The proposal is for Up gradation of effluent management system by disposal of treated waste water through trestle mounted pipelines and diffuser system to Marine outfall point suggested by National Institute of Oceanography

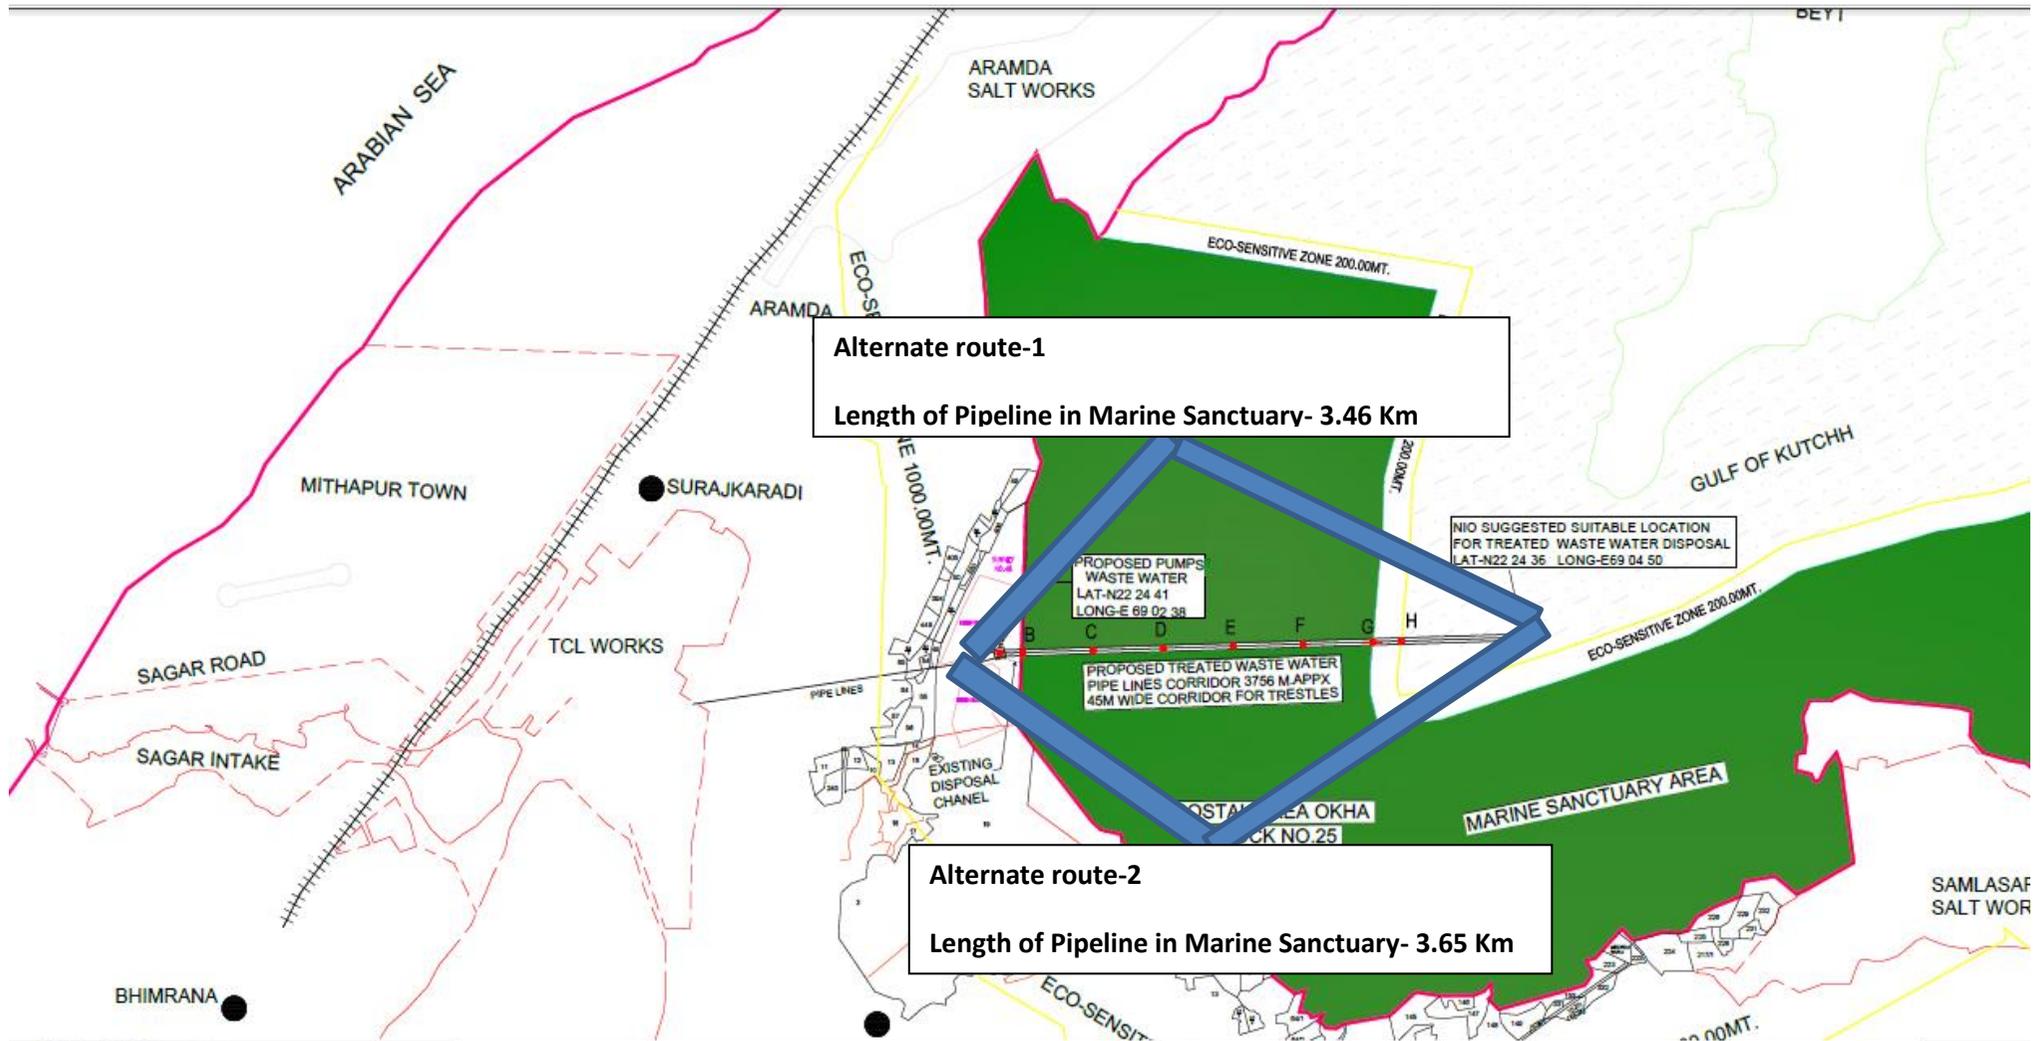
Comparative statement for alternatives shall be submitted.

Response: The proposal is for upgradation of existing effluent management system by disposal of treated waste water through trestle mounted pipelines and diffuser system to Marine outfall point selected by National Institute of Oceanography. Proposed route of treated waste water pipeline system is considered based on least area (11.26 Ha) requirement in notified Marine Sanctuary/ Protected (Section-4) Forest area. Alternative route 1 (Area 15.57 Ha) and route 2 (Area 16.425 Ha) are not considered due to more area requirements in notified marine Sanctuary. Comparative statement showing proposed route and alternate routes are included in Checklist no 35 of the proposal document.

Proposed route: Length in marine sanctuary/ Reserve Forest- 2.504 Km (Area 11.268 Ha)

Alternate route 1: Length in marine sanctuary/ Reserve Forest- 3.46 Km (Area 15.57 Ha)

Alternate route 2: Length in marine sanctuary/ Reserve Forest- 3.65 Km (Area 16.425 Ha)

Alternate route-1
Length of Pipeline in Marine Sanctuary- 3.46 Km

Alternate route-2
Length of Pipeline in Marine Sanctuary- 3.65 Km

Justification: Proposed route is considered based on minimum area requirement in notified Sanctuary. Alternate route-1 and 2 are not considered due to more area requirement in Sanctuary.
